Armonk Private Wells Site

Site Number 3-60-005

New York State Superfund Record of Decision

RESPONSIVENESS SUMMARY

FIGURE 7 - ASSUMED GROUNDWATER REMEDIATION PUMPING SCHEME

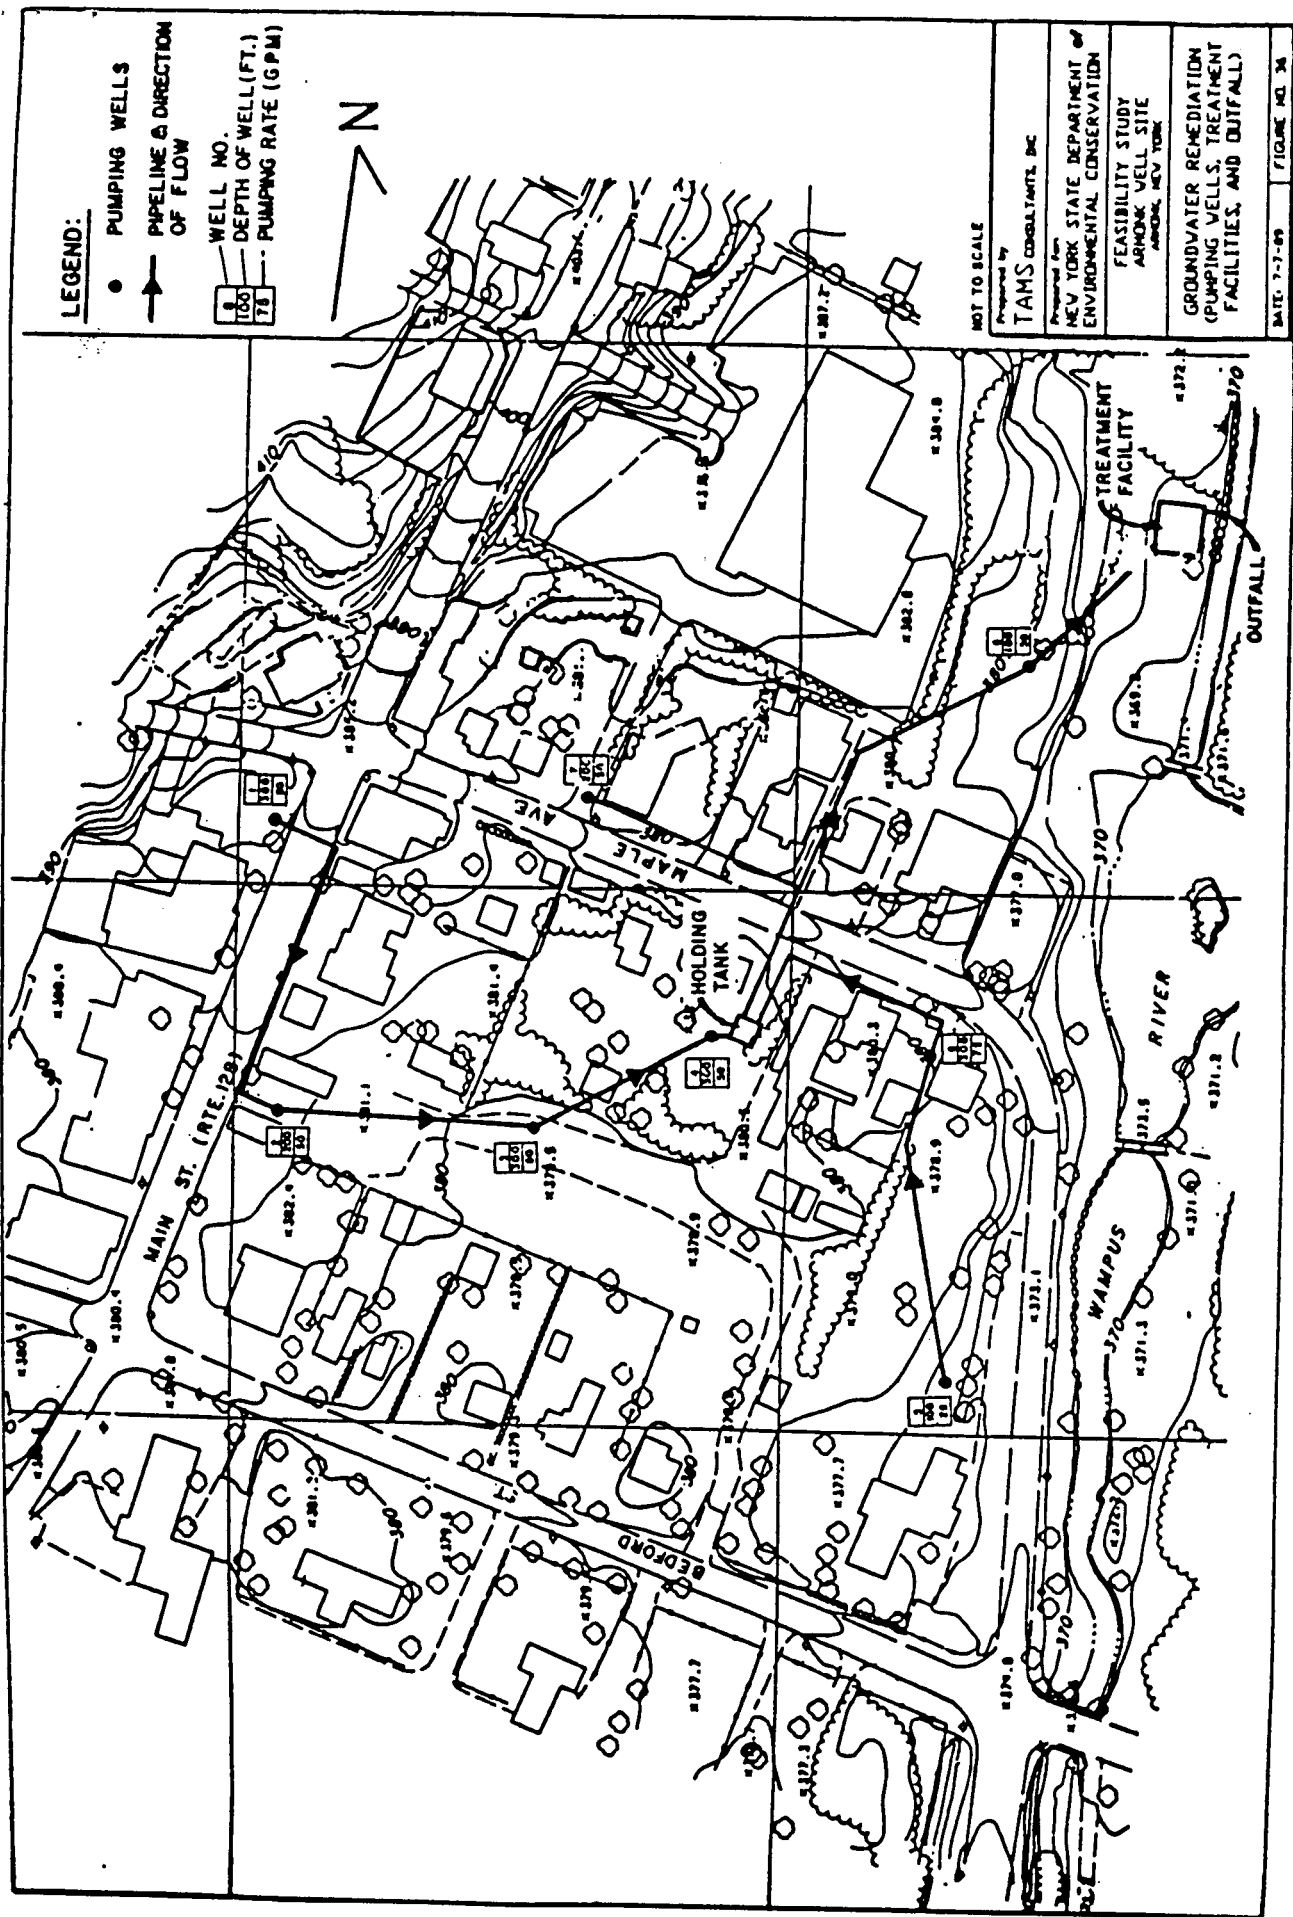
Q17 Figure 6 of the PRAP shows a sketch of the piping system for the pump and treat system. Is this how you plan to do it? Will the pipes run underground?

Ans. The pipes will most probably run underground. As far as where the pipes will run--Figure 6 (Figure 7 of the ROD) is a conceptual plan used for estimating quantities. During design, the actual location of pipes and wells will be established. The final piping location will minimize disturbing the normal activities of the community.
